<b>CITY OF WESTMINSTER</b>			
<b>PLANNING APPLICATIONS COMMITTEE</b>	<b>Date</b> 13 September 2016	<b>Classification</b> For General Release	
<b>Report of</b> Director of Planning		<b>Ward(s) involved</b> Hyde Park	
<b>Subject of Report</b>	33 Westbourne Terrace, London, W2 3UR,		
<b>Proposal</b>	Internal works to the building including the installation of a new lift associated with the reconfiguration of the existing residential accommodation to provide six residential dwellings. External works to include the replacement of windows, new windows, secondary glazing, works at roof level, provision of cycle and car parking spaces and associated refuse areas.		
<b>Agent</b>	DP9		
<b>On behalf of</b>	West Two Properties		
<b>Registered Number</b>	16/03029/FULL and 16/03030/LBC	<b>Date amended/ completed</b>	12 May 2016
<b>Date Application Received</b>	5 April 2016		
<b>Historic Building Grade</b>	Grade II listed

<b>Conservation Area</b>	Bayswater

**Proposed South Elevation**

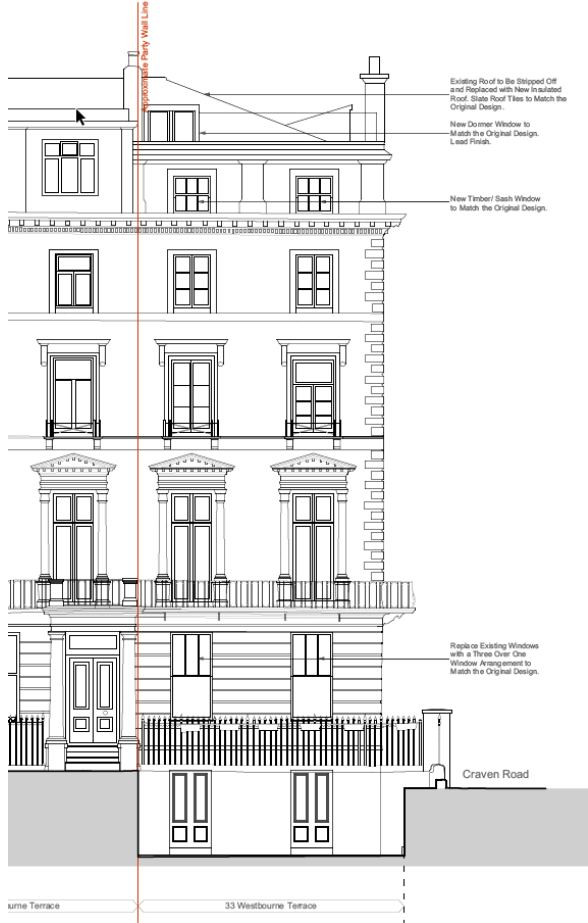
The glass balustrading proposed to these locations on the Westbourne Terrace and Craven Road parapets is designed as large sheets of glazing which would be highly prominent to roof level, and wholly out of character with this traditional, classically inspired building. The glazing would catch the sun in a reflective manner ensuring that it stood out markedly to roof level in views from both street level and surrounding buildings and in these views would be highly prominent to roof level. Access to roof level is possible through a staircase and narrow window, but nonetheless the glazing would not be anticipated to be cleaned on a regular basis to this narrow roof level area. Adjacent to these busy roads and with numerous trees in the surrounding area, it is likely that these glass balustrades would become dirty and more prominent over time. The impression of large prominent glass panels projecting from a parapet, which was originally designed to

be seen against the sky without structure above or behind, would break an important part of the classical character of the building. Accordingly, the proposed balustrades would be particularly harmful to the character and appearance of this listed building and the surrounding conservation area.

However, the front dormer would be unacceptable. The building occupies a prominent corner site on Westbourne Terrace which is one of the principal routes through Bayswater. The terraces to Westbourne Terrace were originally designed with, and still retain, a clear impression of being seen as palace fronted compositions with the end bays and central bays having sheer elevations to their top floor level, with visually subservient mansard top floors between these principal central and end bays. To a street junction such as this, each of the four terraces terminating at the junction has its end bays rising to a sheer top and giving a distinct grandeur to the townscape, with their roof structures deliberately kept very low in profile so as not to break the strong, sheer classical composition of the buildings and terrace as a whole to ensure they read clearly as the end blocks to each palace fronted composition. There is some limited variety now to the designs of these top floors on the junction, but the original design conception is still clearly apparent.

The existing front dormer is visible from the west side of the street and from further west down Craven Road though it is relatively low profile to the roof. The extension of the dormer forward onto the front parapet and its increase in width would significantly increase its visual impact on the building. This would harm the character and appearance of this building, the architectural conception of this terrace as having end bays and the classical character of the building. When seen above this composition, the enlarged and more prominent dormer would have a wholly inappropriate and cluttering impression, harmful to the character and appearance of the building, terrace and conservation area as a whole.

The front dormer is also relocated adjacent to the north party wall, which also serves as an inappropriate alteration. In this position it would be markedly set off line with the windows below, further serving to highlight its inappropriateness and lack of integration with the special architectural and historic interest of this listed building and the character and appearance of the area.

- Reason:
- 2 Because of its height, location and materials, the glass balustrade would harm the character and appearance of this grade II listed building. It would also fail to maintain or improve (preserve or enhance) the character and appearance of the Bayswater Conservation Area. This would not meet S25 and S28 of Westminster's City Plan (July 2016) and DES 1, DES 6, DES 9, DES 10 (A) and paras 10.108 to 10.146 of our Unitary Development Plan that we adopted in January 2007. (X17AC)

- 5 Because of its size, design and location, the enlarged dormer window to the Westbourne Terrace elevation would harm the character and appearance of this grade II listed building. It would also fail to maintain or improve (preserve or enhance) the character and appearance of the Bayswater Conservation Area. This would not meet S25 and S28 of Westminster's City Plan (July 2016) and DES 1, DES 6, DES 9, DES 10 (A) and paras 10.108 to 10.146 of our Unitary Development Plan that we adopted in January 2007. (X17AC)

Proposed Lower Ground Floor

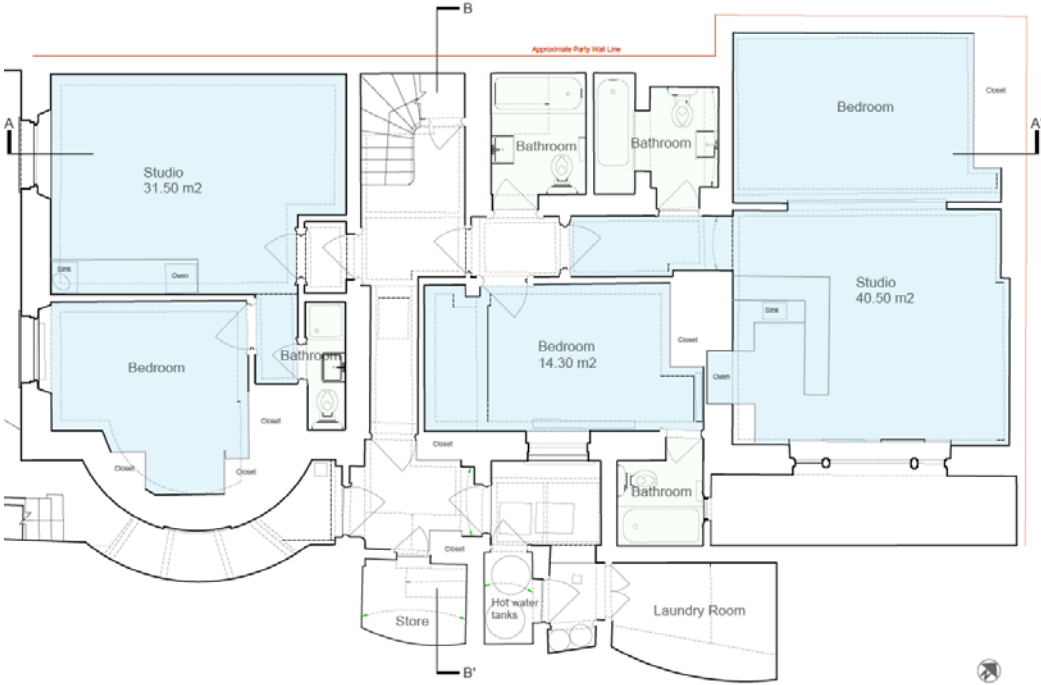
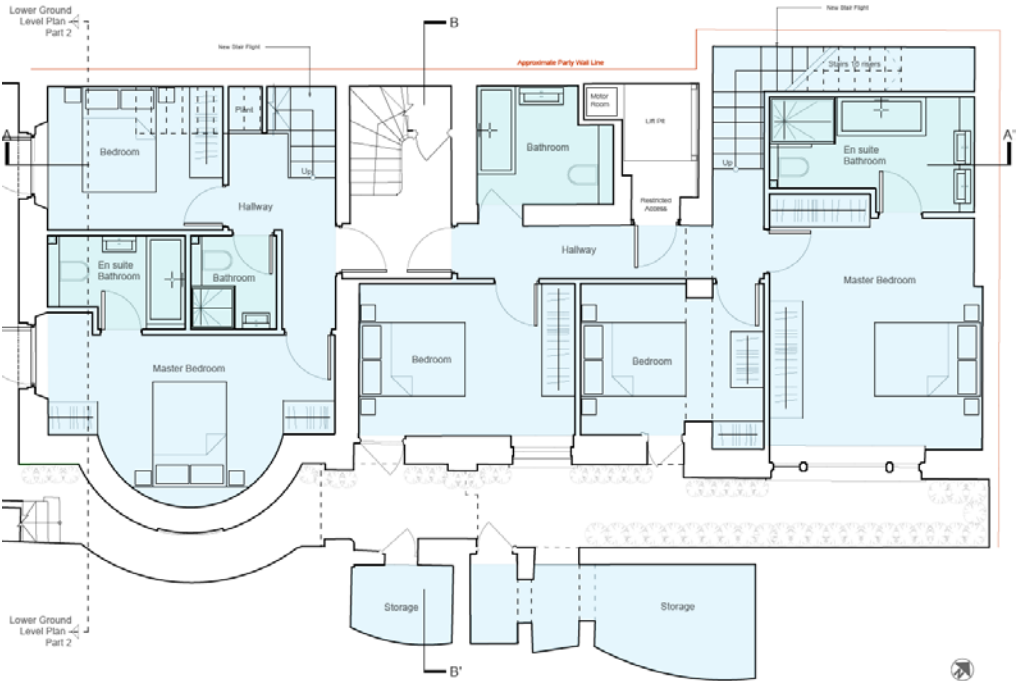
To lower ground floor level on the Westbourne Terrace elevation, the two six over six sash windows are likely to be original to the building. The applicant proposes removing these windows and replacing them with doors. Removal of these windows would result in loss historically appropriate and possibly original windows from the building. The new doors would not be an appropriate feature set into the front elevation to lower ground floor level and the consequent enlargement of the opening to accommodate them unbalances the proportioning of the composition. Accordingly, removal of these windows and their replacement with doors would harm the special architectural and historic interest of this listed building.

- 4 Because of the loss of the existing windows and the design of the doors, the removal of windows and replacement of doors to lower ground floor level on the Westbourne Terrace elevation would harm the character and appearance of this grade II listed building. It would also fail to maintain or improve (preserve or enhance) the character and appearance of the Bayswater Conservation Area. This would not meet S25 and S28 of Westminster's City Plan (July 2016) and DES 1, DES 5, DES 9, DES 10 (A) and paras 10.108 to 10.146 of our Unitary Development Plan that we adopted in January 2007. (X17AC)

Proposed Ground Floor

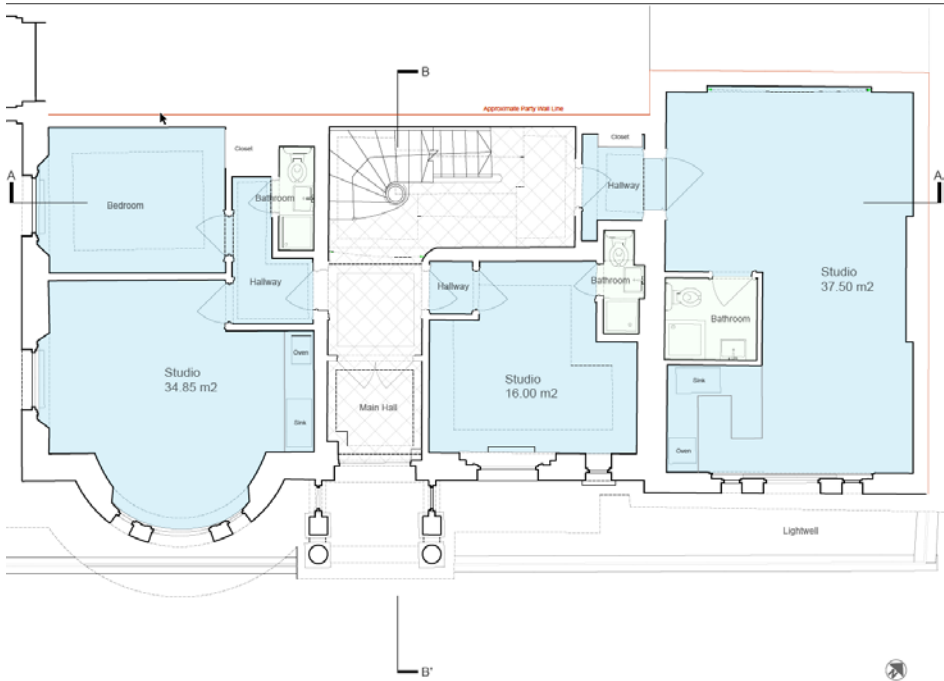
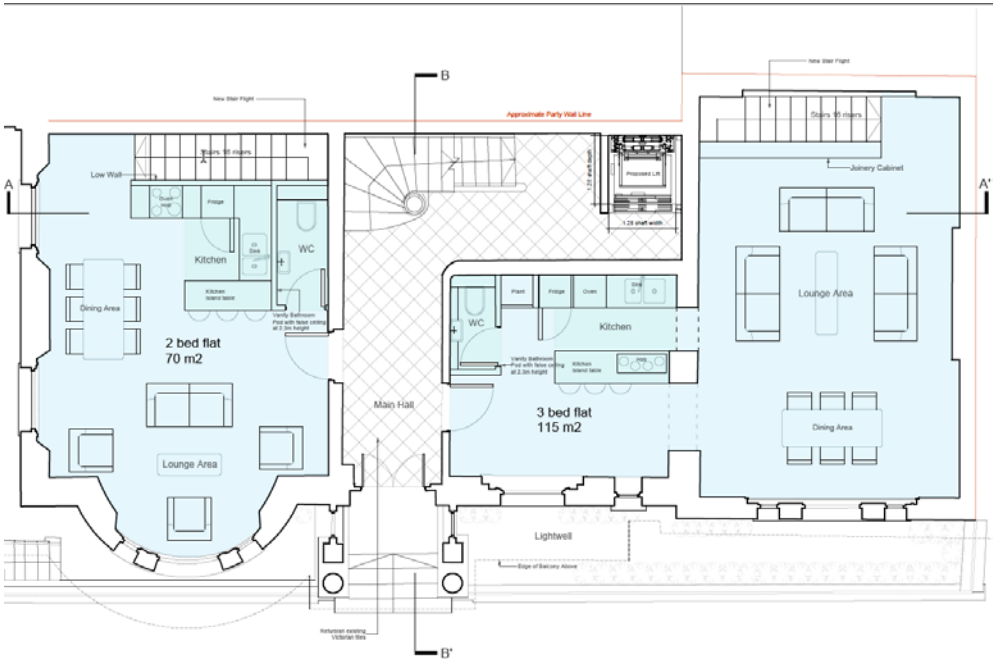
To lower ground floor level, given the significant alterations to this part of the building, the works are not considered harmful in themselves. However, above this level the works would be harmful to the character of the building. The installation of a lift structure set directly into the ground floor level hallway, with modern lift car doors opening out onto this

area would be a retrograde step from the existing situation. To first and second floor levels the panelled reveals to the openings would be removed with consequent loss of original fabric and an attractive feature of the interior. To first floor level, the lift structure would step out into and partly enclose the space within the reveal. At second floor level, the lift would step out beyond the line of the infill and cuts directly through the rising steps of the staircase and at third floor level it would cut directly through the landing. To fourth floor level the lift would cut into the rear of a room. The impact upon the staircase through the encroachment onto these areas would be harmful due to the narrowing of what was originally intended to be an open and generous space and through removal of original fabric in the form of original stone steps and landing structures and panelled reveals to several of the openings.

largest. The Heritage Report submitted states that it appears to have late Victorian skirting in place, but otherwise modern finishes, and it also appears to retain a framed niche to the north wall which is likely to be original. This room largely retains a clear sense of its original volume and proportions without any permanent intervention breaking into the clarity of the space. There is no evidence of any staircase having been present in this room as is the case with the western room to this floor level. Accordingly, the staircase would be a wholly inappropriate intervention into the space, removing historic fabric in the form of the floor structure to be cut away, creating a circulation route from one of the grandest rooms within this mid-19th century property directly to lower ground floor level in a manner wholly out of character with the clear separation between such grand rooms and service spaces in such houses, and converting a section of a grand reception room into circulation space. The void would also provide a notable break in the appreciation of the volume of the room. This work would be harmful to the character of the building and is considered unacceptable.

There are currently a series of windows to ground floor level on the Craven Road and Westbourne Terrace elevation, none of which are likely to be wholly original to the building. Most are in a one over one arrangement and appear later replacements. One window on the Craven Road frontage has a three over one arrangement and the top sash (subdivided into three glazing bars) is almost certainly original as it matches others to such locations in the street and would have originally had a matching lower sash subdivided into three panes of glass. The applicant seeks removal of two of the windows to ground floor to each street elevation and their replacement with new three over one sash windows. This arrangement is without precedent for such mid Victorian buildings and it takes an unfortunate change to one Craven Road window and repeats it across much of the ground floor. Having a top sash subdivided into three with a single pane of glass below gives an unbalanced arrangement which is wholly inappropriate for this building, is at odds with the arrangement of glazing bars elsewhere in the building and terrace generally and would be unacceptable.

- Reason:
- 3 Because of their design/arrangement of glazing bars, the new windows to the Craven Road and Westbourne Terrace elevations at ground floor level would harm the character and appearance of this grade II listed building. It would also fail to maintain or improve (preserve or enhance) the character and appearance of the Bayswater Conservation Area. This would not meet S25 and S28 of Westminster's City Plan (July 2016) and DES 1, DES 5, DES 9, DES 10 (A) and paras

- 7 Because of the impact upon the ground floor eastern room including its plan form and volume/character, the new staircase from the ground floor eastern room into lower ground floor level would harm the character of this grade 2 listed building. This would be against the advice set out in S25 and S28 of Westminster's City Plan (July 2016) and DES 1 of our Unitary Development Plan that we adopted in January 2007 and the advice set out in paragraphs 6.18, 6.19, 6.20 and 6.23 of our 'Supplementary Planning Guidance: Repairs and Alterations to Listed Buildings'. (X18AB)

Proposed First Floor

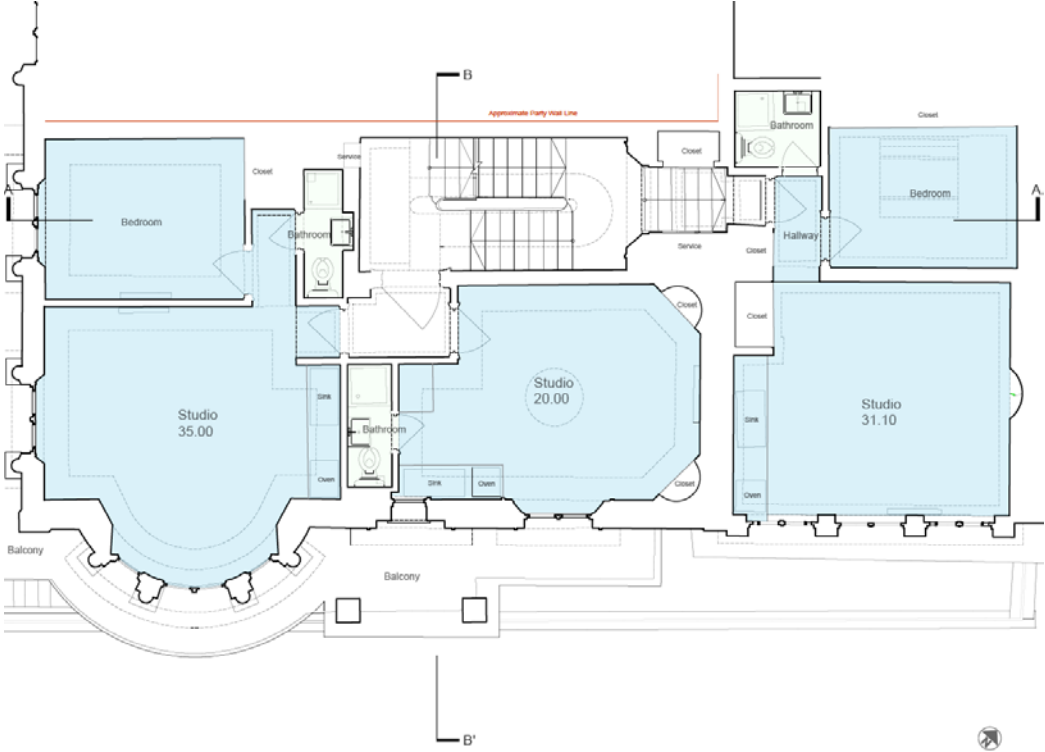
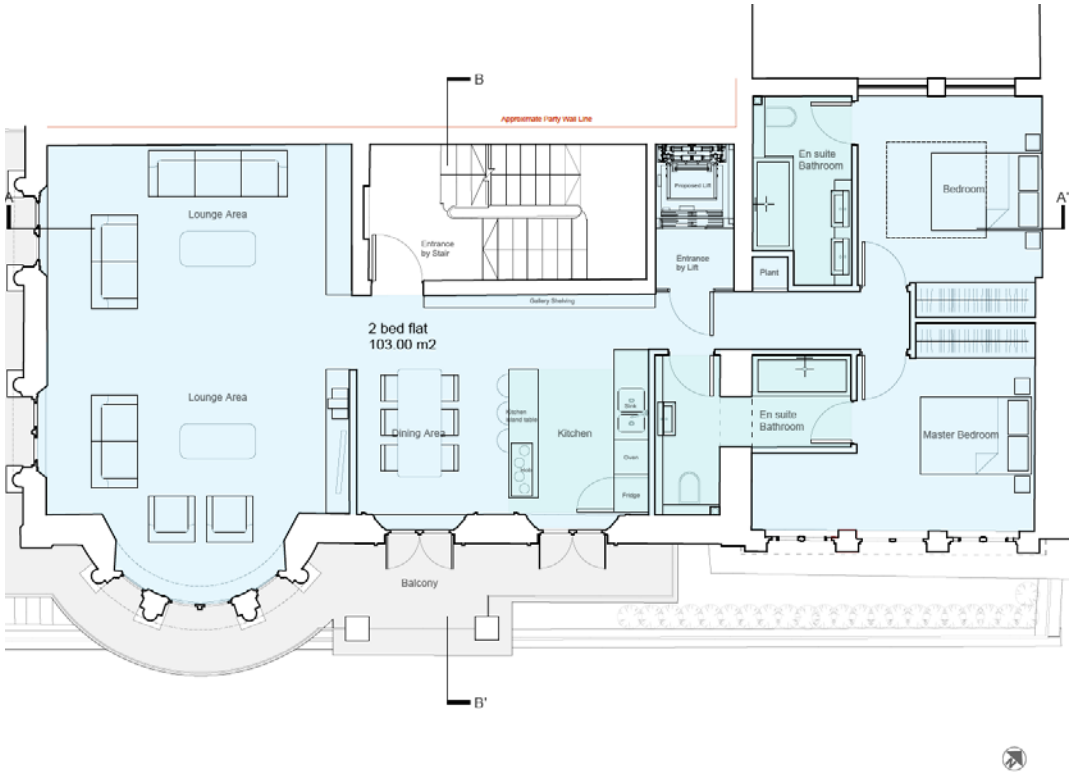
No clear information has also been given of the structural implications of the works with regards to the staircase landing structures at first, second and third floor levels although there is a suggestion in the engineering statement that significant internal steelwork could be used. The lift cuts through a number of areas which would typically be formed by a single stone landing or step structure and the truncation of it could put the staircase at extreme risk of collapse, cause harmful cracking of stone or require provision of further supporting structures to mitigate the loss of its attachment to the rear elevation. This would harm the originally intended and still remaining slenderness of steps/landing which are a key feature of its appearance and grandeur.

Provision of the lift would also require additional partitioning at first, second, third and fourth floor levels. This new arrangement would truncate the still discernible original internal layout of the building, partly converting a number of rooms into circulation spaces. This would harm the character of the interior by the creation of new corridors through important internal spaces and would fundamentally alter the appreciation of the building as one with a single staircase circulation route to one where a new and entirely separate modern lift and corridor route would be created. This would wholly alter the original floor plan harming the character of the interior.

- 5 Because of the loss of historic fabric, the harm to the character of the staircase space, the impact upon the layout and circulation space to the building and the lack of structural justification, the insertion of a lift between ground and fourth floor levels and corridor partitions associated with the creation of the circulation routes for the lift would harm the character of this grade 2 listed building. This would be against the advice set out in S25 and S28 of Westminster's City Plan (July 2016) and DES 1 of our Unitary Development Plan that we adopted in January 2007 and the advice set out in paragraphs 6.18, 6.19, 6.20, 6.23, 6.27, 6.33 and 6.34 of our 'Supplementary Planning Guidance: Repairs and Alterations to Listed Buildings'. (X18AB)

**Proposed Third Floor**

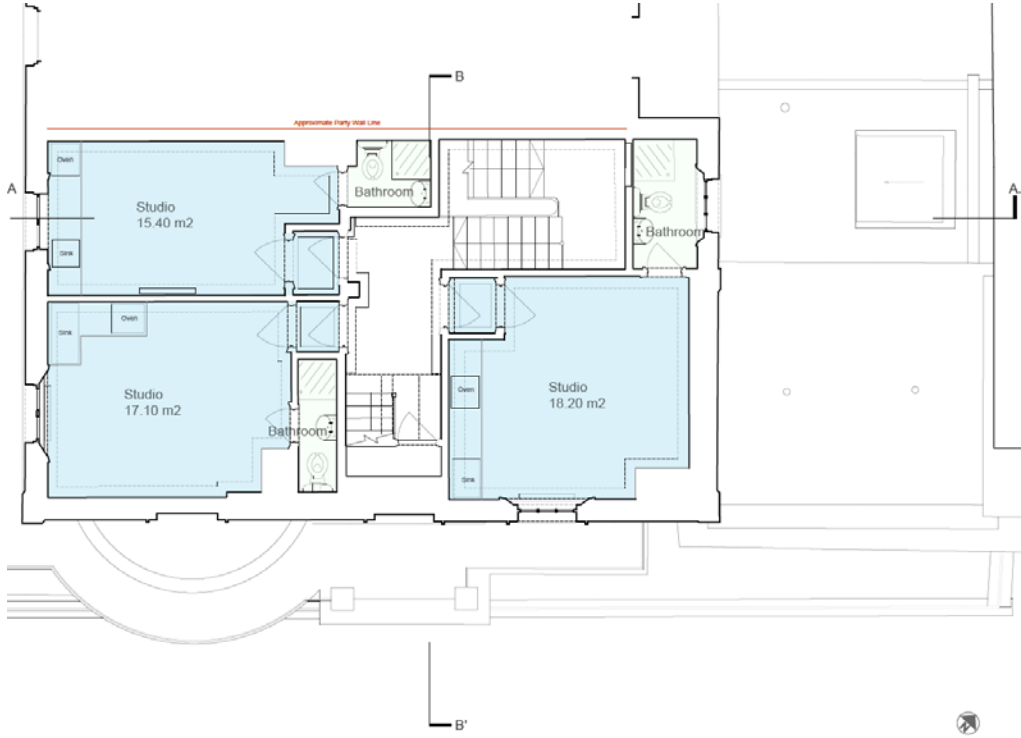
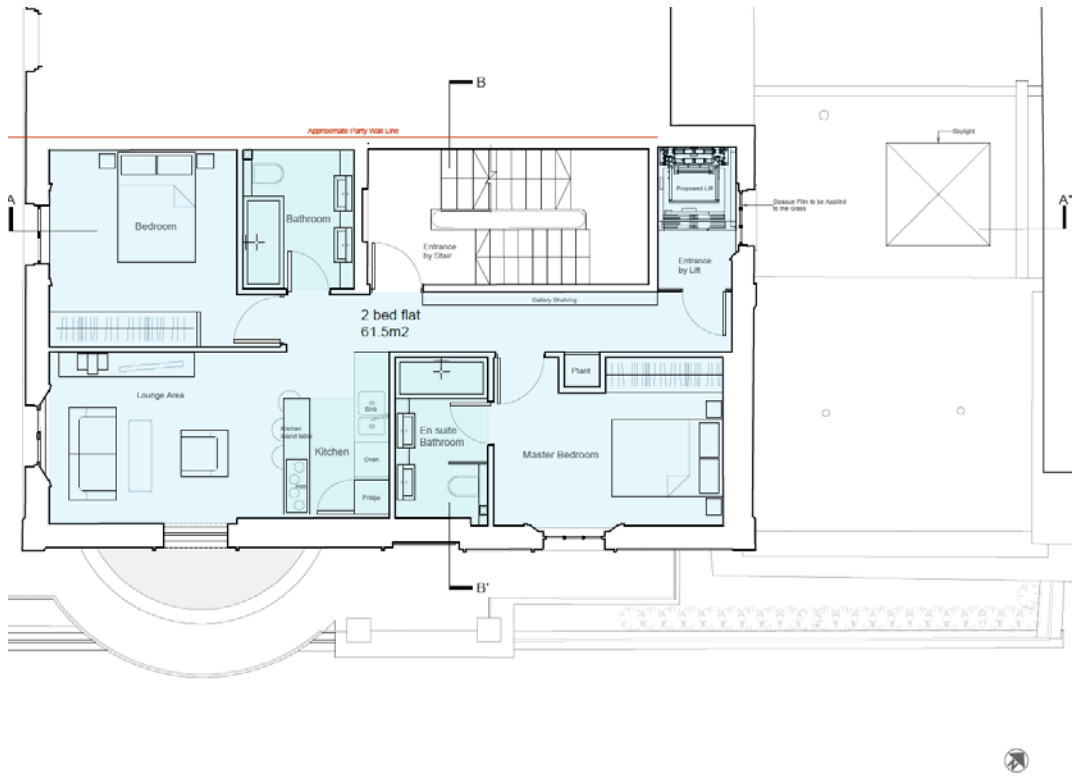
The application seeks to remove the existing secondary staircase which rises from third to fourth floor levels and to replace it with a new timber staircase rising from third to fourth floor levels as a continuation of the existing main grand staircase rising from ground floor. This building was originally designed with a grand staircase rising from ground to third floor levels and there was also originally a much simpler secondary staircase rising from third floor level to fourth floor level as a distinct and separate structure from the main staircase.

It is noted that the secondary staircase from third to fourth floor levels is clearly a more modern staircase. However, for a grand Victorian town house such as this it appears highly unlikely that what would have been servants accommodation to fourth floor level would have been accessed by a continuation of the grand staircase, nor by any form of 'differently designed' staircase as a continuation of the grand staircase. There is a clear pattern in Victorian townhouses throughout this part of Bayswater of secondary staircases being clearly distinct and separate structures, reflecting the social distinction between the owners of the building and their servants.

The treads are shown to a much thicker depth than the than the stone steps to the existing main staircase, and appear inelegantly thick in section. The balustrading to the staircase would be mounted off the ends of each of the treads which is a constructional approach and detailing which is characteristic of stone staircases but is not traditional for timber staircases to such terraced properties. The new staircase would not appear as a seamless addition to the main staircase, but instead as a visually jarring addition above.

The secondary staircase proposed would therefore harm the special architectural and historic interest of this listed building.

- 6 Because of the loss of historic plan form and impact on the character of the existing ground to third floor level staircase, the creation of a new timber staircase from third to fourth floor levels would harm the character and appearance of this grade 2 listed building. This would be against the advice set out in S25 and S28 of Westminster's City Plan (July 2016) and DES 1 of our Unitary Development Plan that we adopted in January 2007 and the advice set out in paragraphs 6.18, 6.19 and 6.23 of our 'Supplementary Planning Guidance: Repairs and Alterations to Listed Buildings'. (X18AB)
